Product/Process Change Notice (PCN)

PCN Number: PCN_AsCLUG_20241129

Affected Series: WA-CLUG

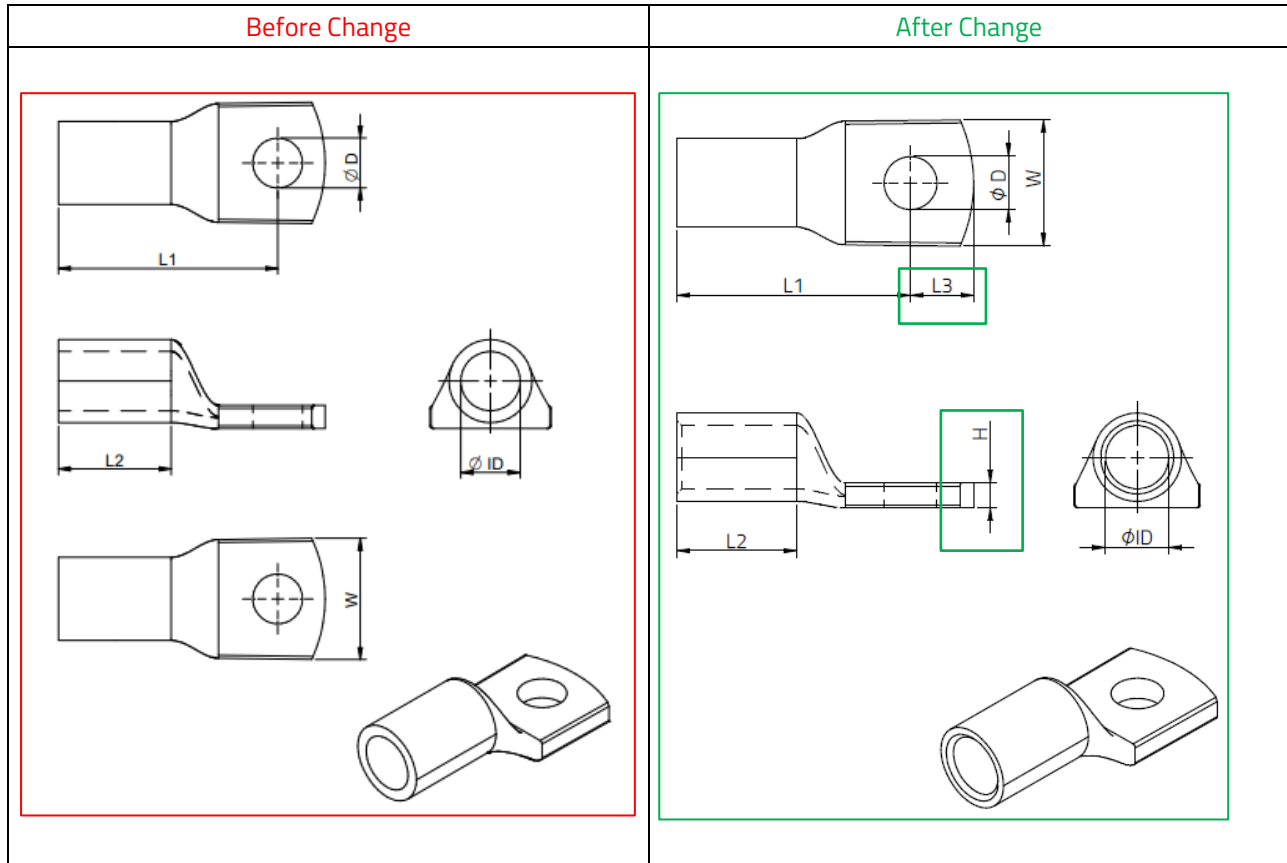
Datasheet will be updated with some additional dimension.

Additional dimension in the datasheet will be added:
